Accessibility Report

New Primary School in Murrumbateman 2 Fairley Street, Murrumbateman, NSW

Report No: MURR-DD-SSDA-RPT-0001
Revision: A
Date: 14 May 2021

BLOCK C - GROUND FLOOR - FURNITURE PLAN

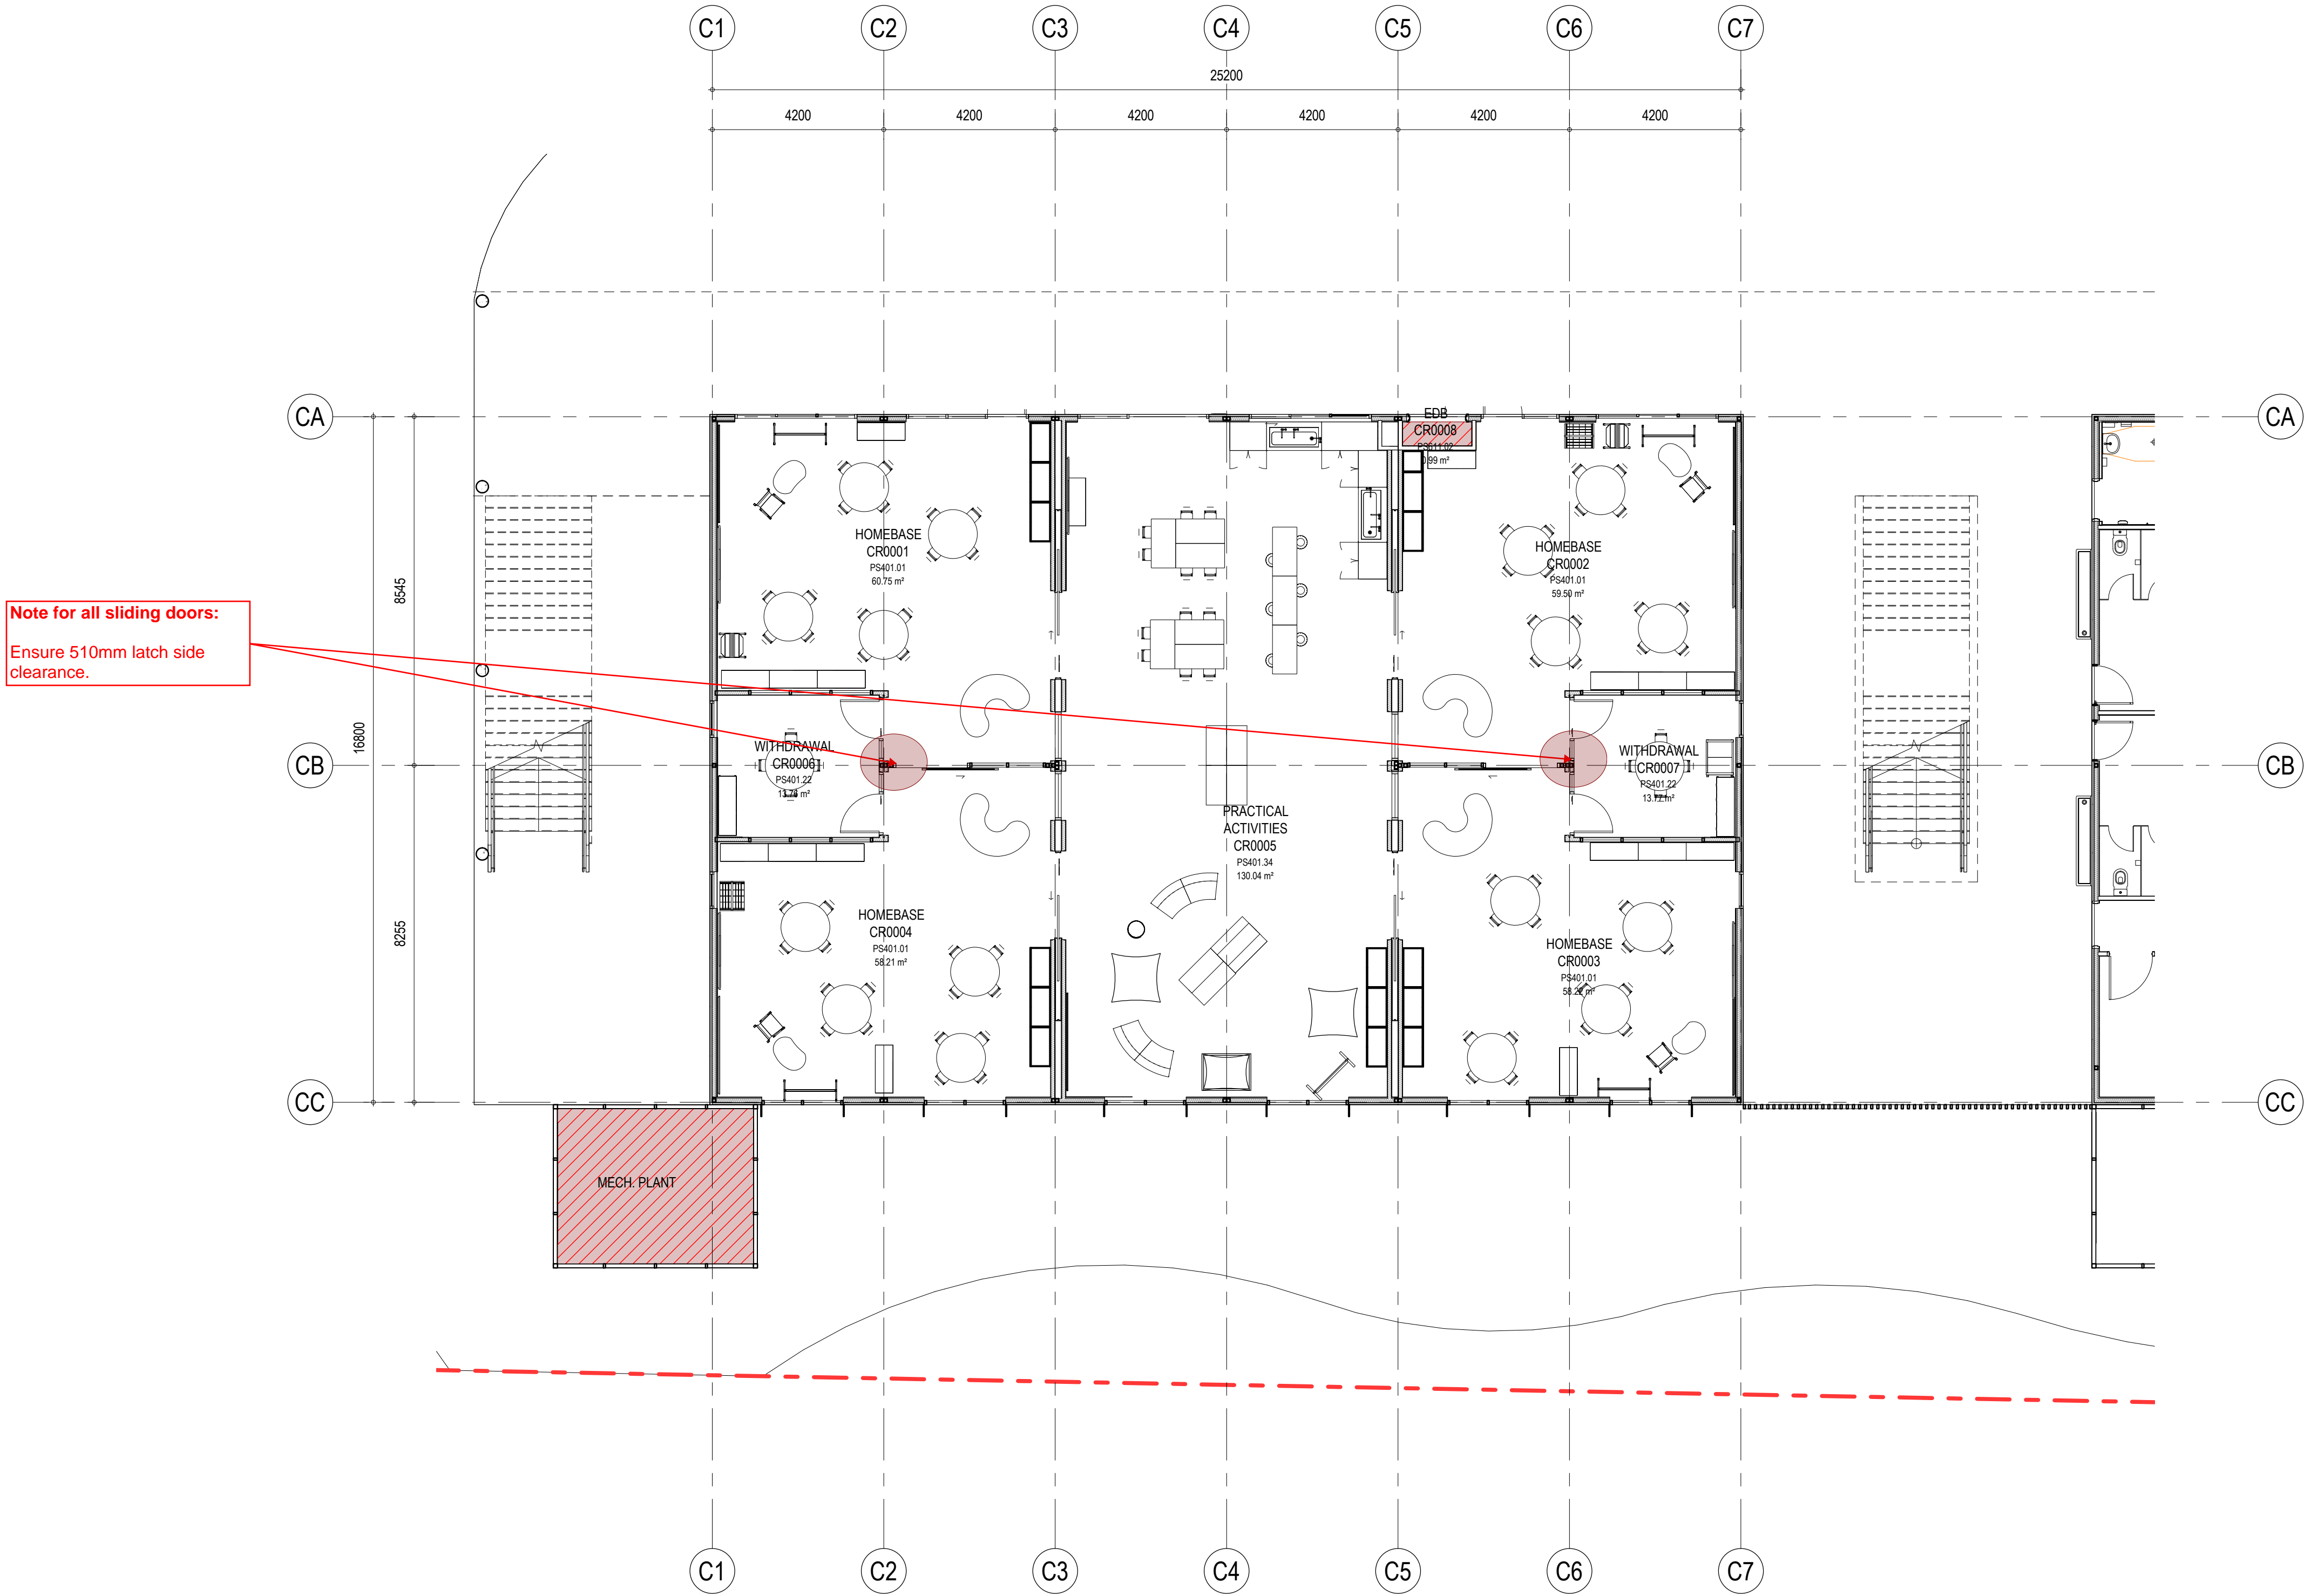
Areas that may be applicable for exemption from disability access under BCA Clause D3.4, provided Client can verify use and users of these areas.

DRAWING NAME
BLOCK C - FIRST FLOOR - FURNITURE PLAN

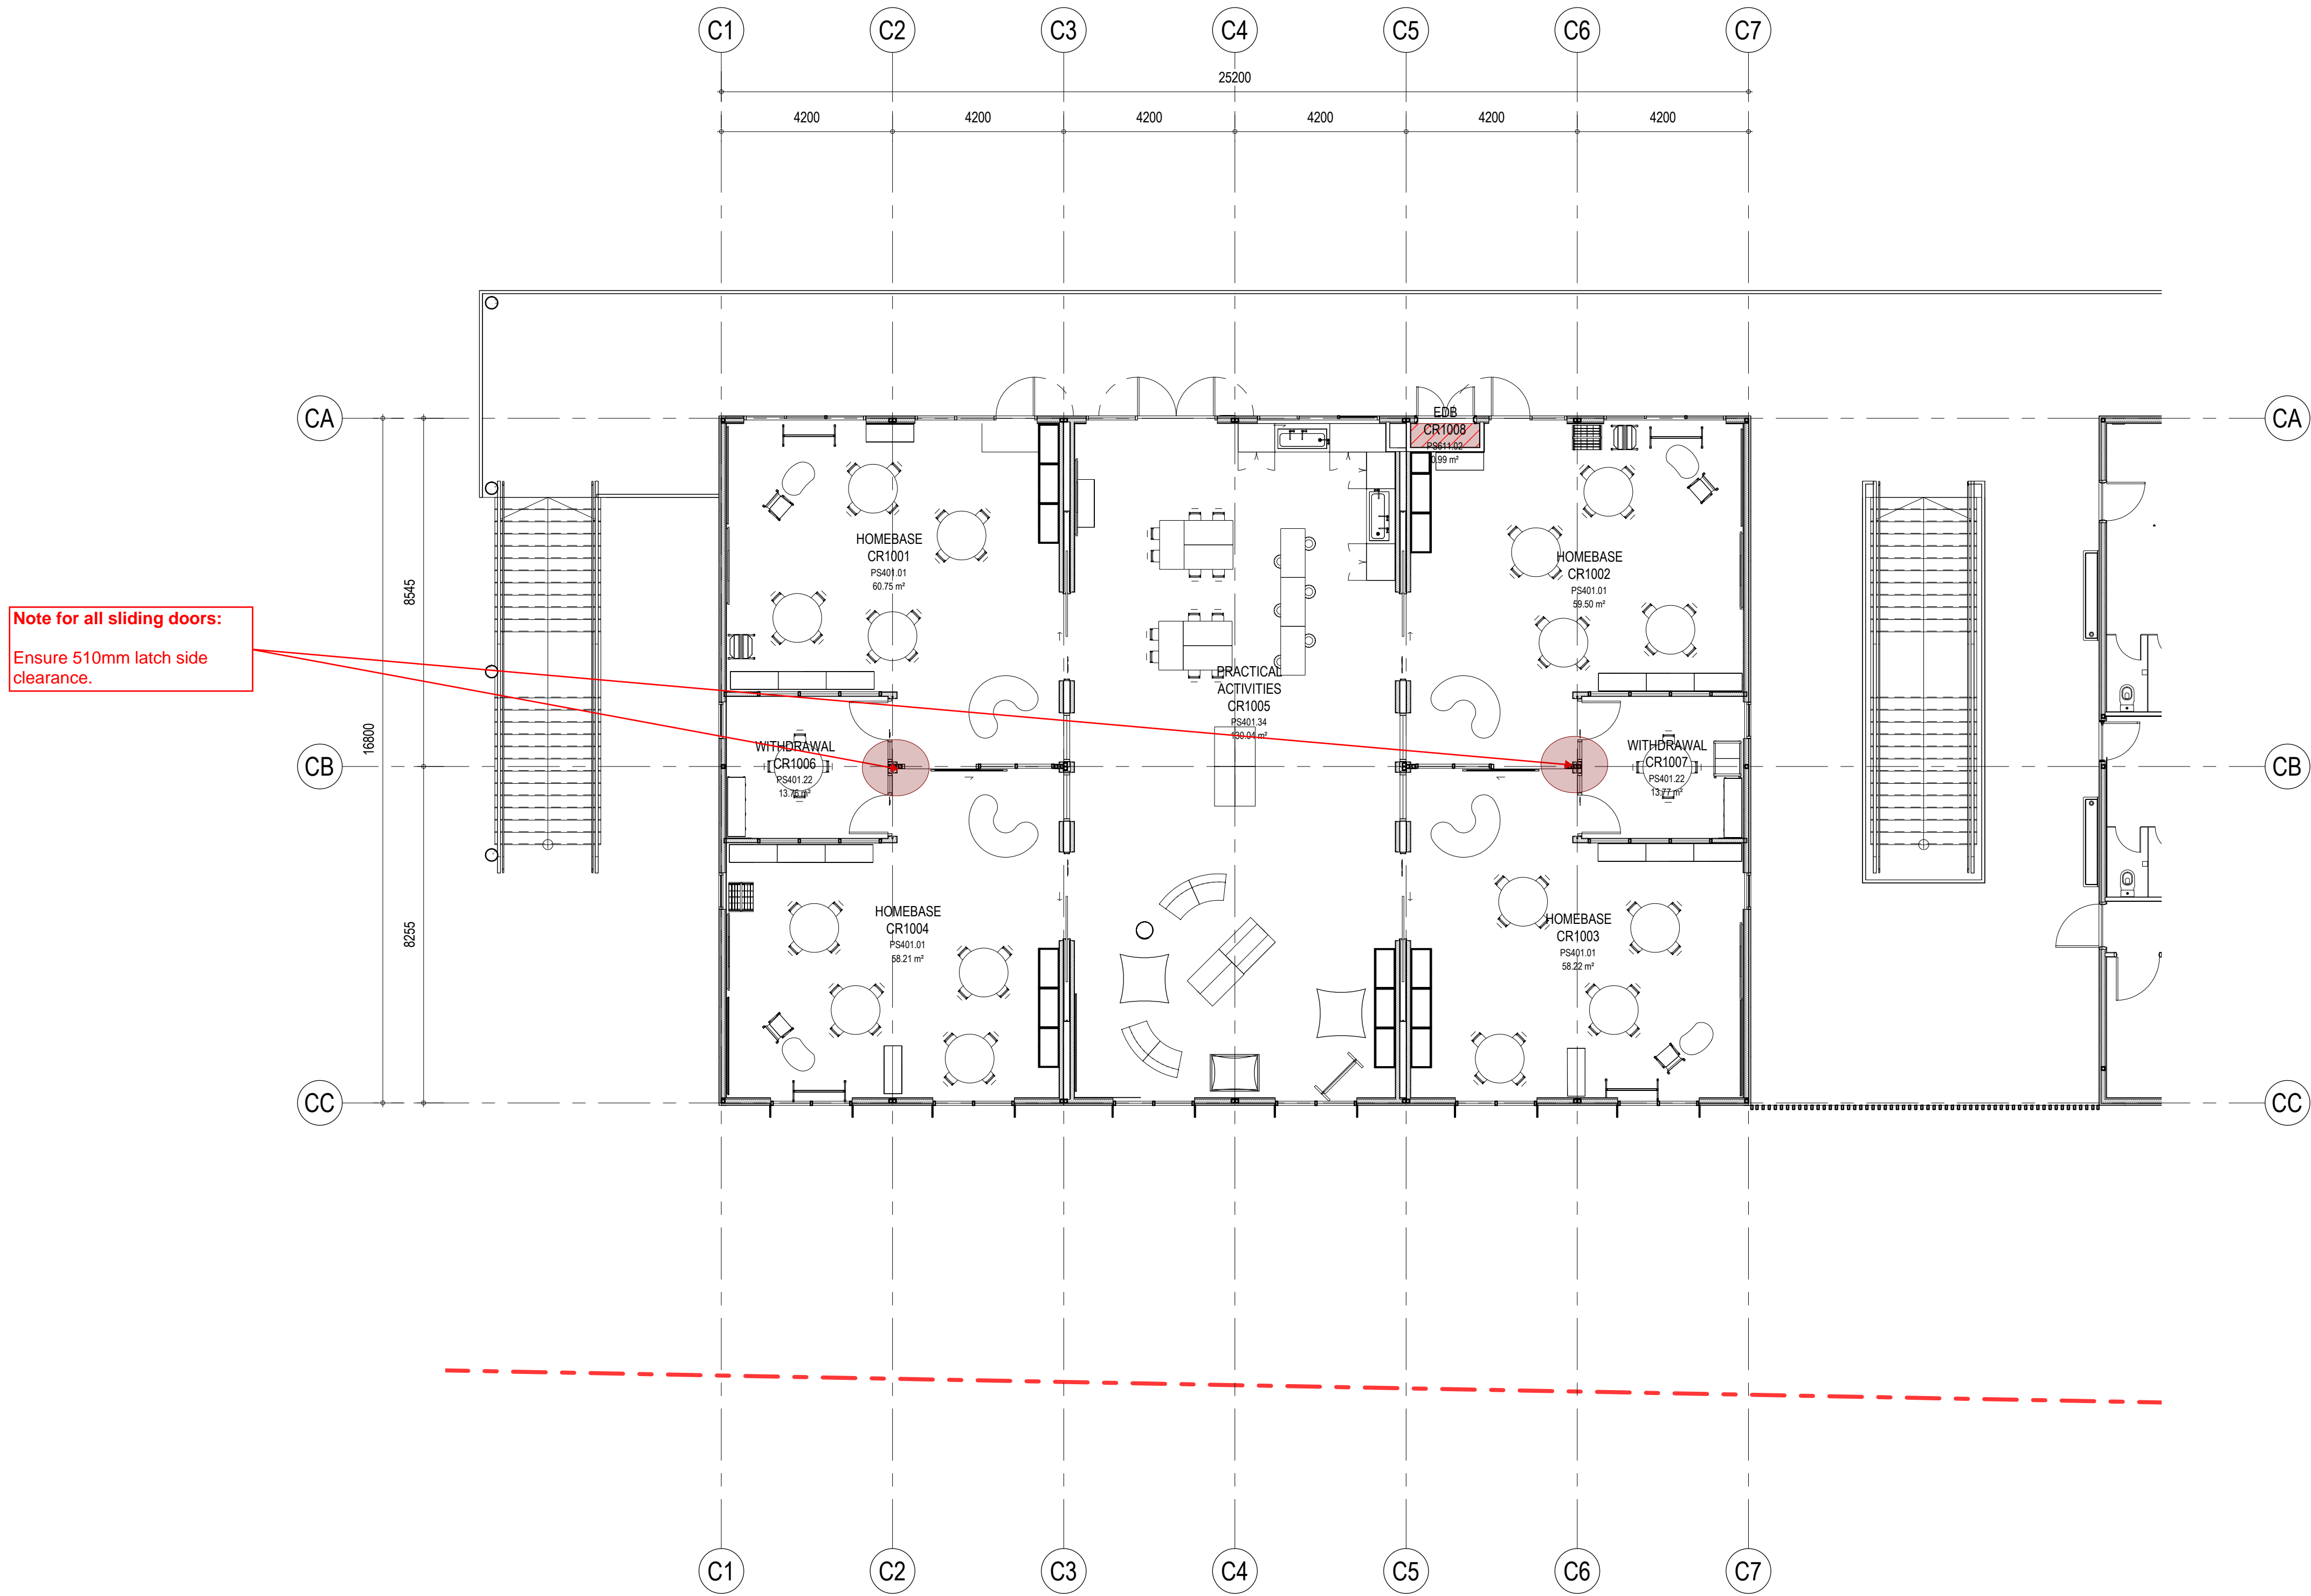
Areas that may be applicable for exemption from disability access under BCA Clause D3.4, provided Client can verify use and users of these areas.

BLOCK D - GROUND FLOOR PLAN

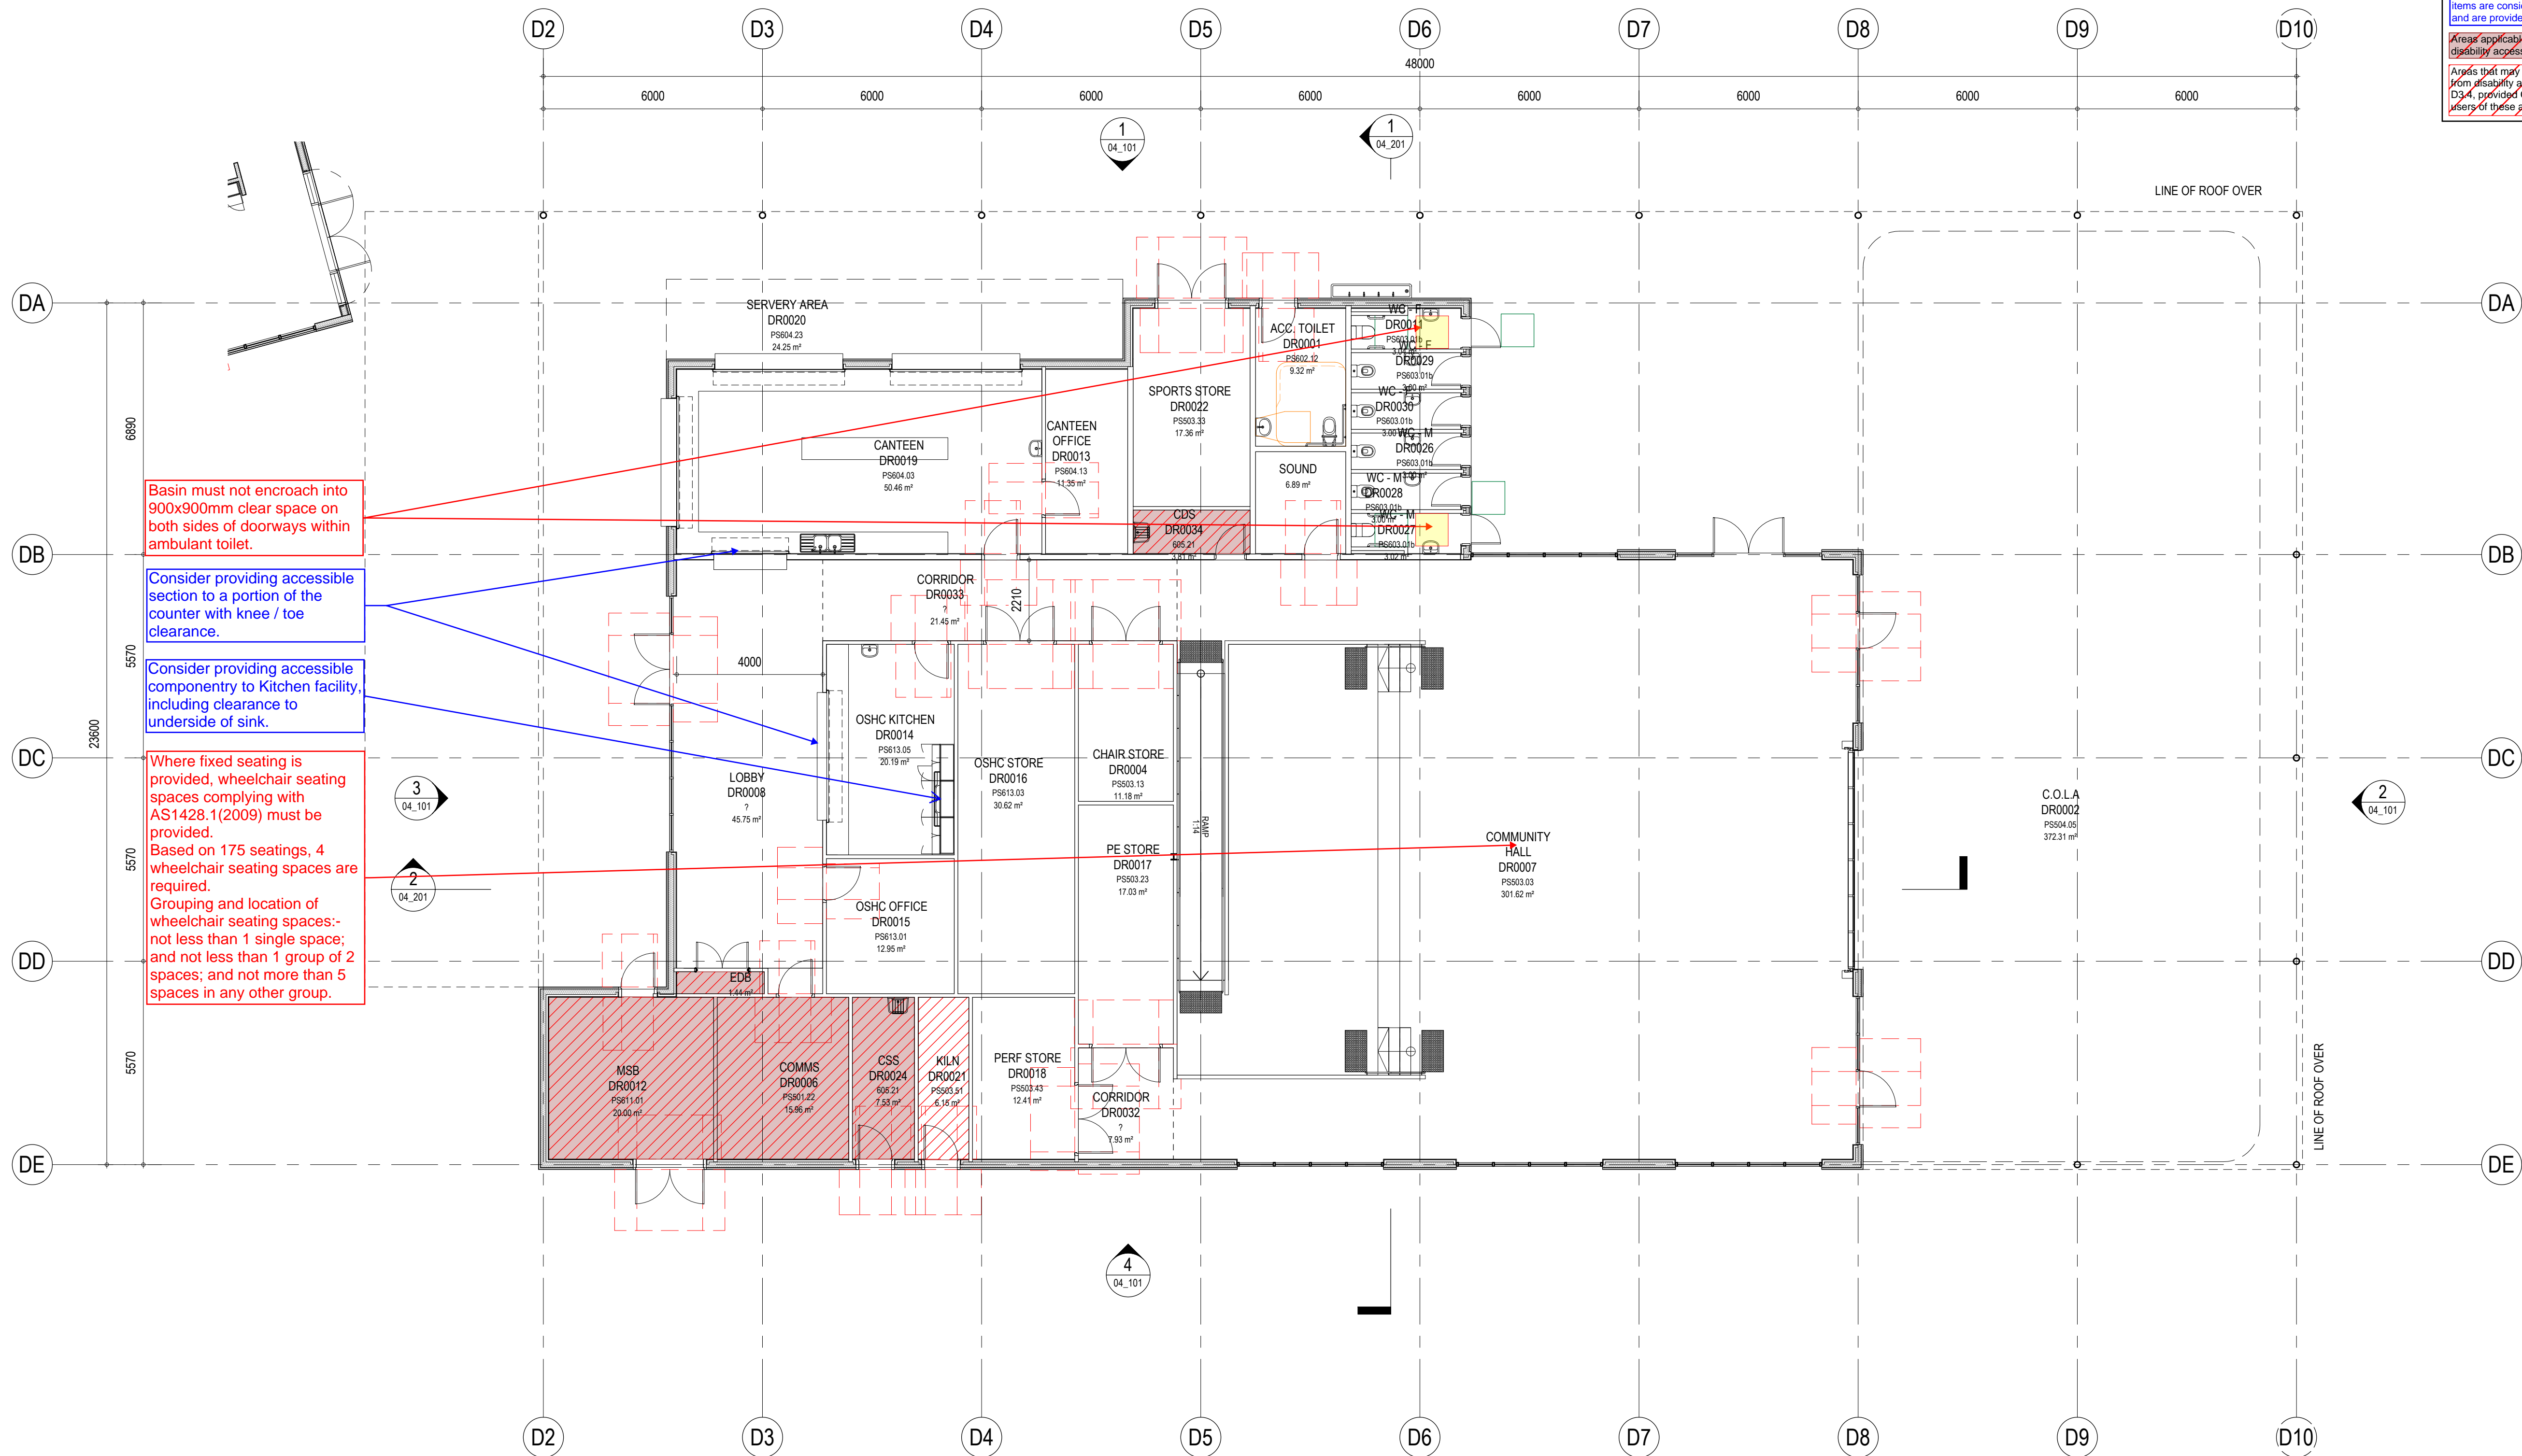
Areas that may be applicable for exemption from disability access under BCA Clause D3.4, provided Client can verify use and users of these areas.
